From: Jones, William V., EMNRD
Sent: Tuesday, July 31, 2012 5:30 PM
To: 'Mark Fairchild'
Cc: Ramon Reyes
Subject: RE: SWD Permit Depth Change

Will, we have drilled our Loco Hills SWD 33 #6, 30-015-39478. This well came in approx. 150' high to our projections. This therefore puts our applied for and approved injection interval outside of some of the porosity that we wanted to have in the disposal interval. What steps would be required to add 100' to our original C108 permitted depths? Thanks for your time!

Well: Loco Hills SWD 33 #6
API: 30-015-39478 SWD Permit: 1285
Elev: 3,621.5 KB; 3,603 GL
Location: 2210 FNL; 2145 FEL, Unit Ltr. G, Sec 33, T17S; R30E, Eddy Co., NM

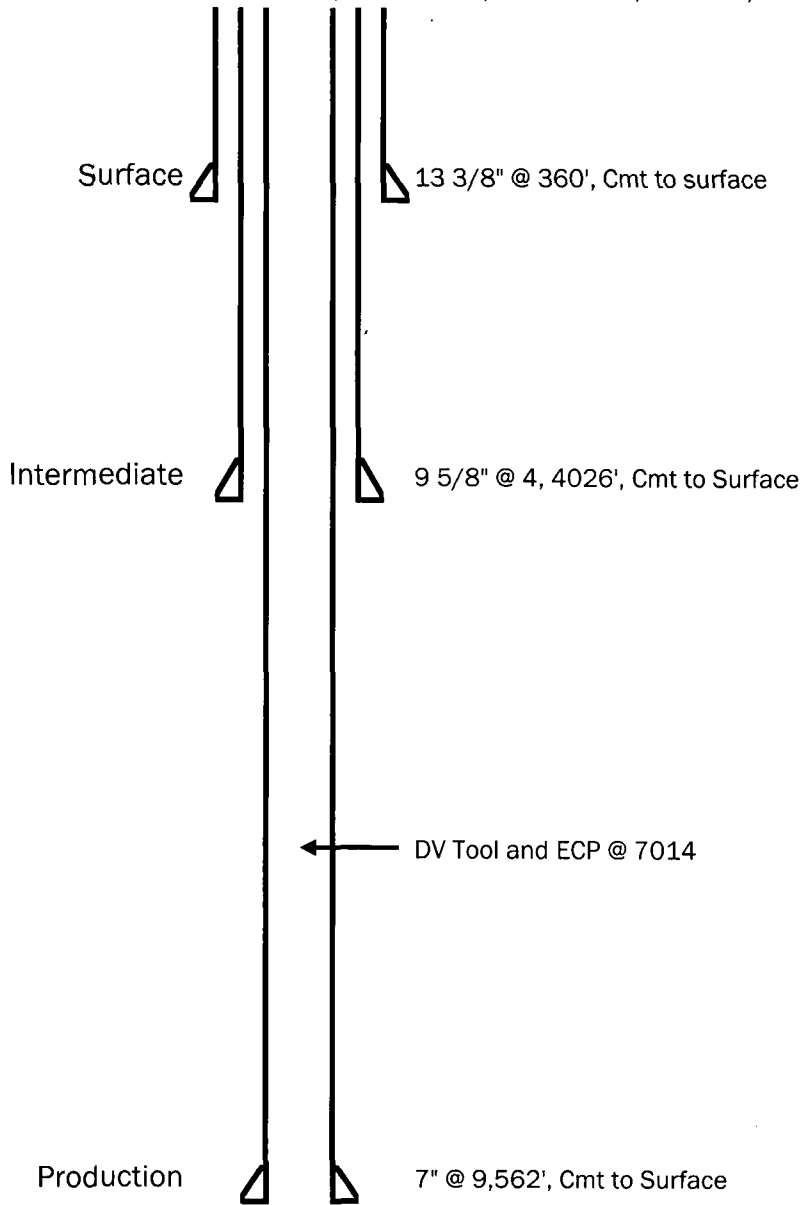
Also thanks for the nice Excel wellbore diagram – I collected that one.

- a. Why ask for 100 feet when it really is 150?
- b. Is it the same formation(s)?
- c. What is the permit SWD number?
- d. Did the original permit say "approximately" for the depths of disposal?
- e. Send a new wellbore diagram.
- f. If it came in high – does that mean it was oil/gas productive?
- g. How does this change the Area of Review – any wells to be concerned about?
- h. Was the well site moved laterally from the original permit?

1. The main porosity intervals in the Wolfcamp reef exist from 8,538 to 8,909. The small interval above our applied for depths is probably not significant, but the lower porosity is.
2. Formation is the Wolfcamp Reef, same as applied for.
3. SWD 1285
4. There was no approximately in the original permit application.
5. Wellbore diagram with tops attached.
6. There were no oil and or gas shows encountered.
7. Area of review does not change.
8. The wells was not moved in any way from that permitted.

If possible, the interval from 8,538 to 8,909 would be our objective to get permitted.
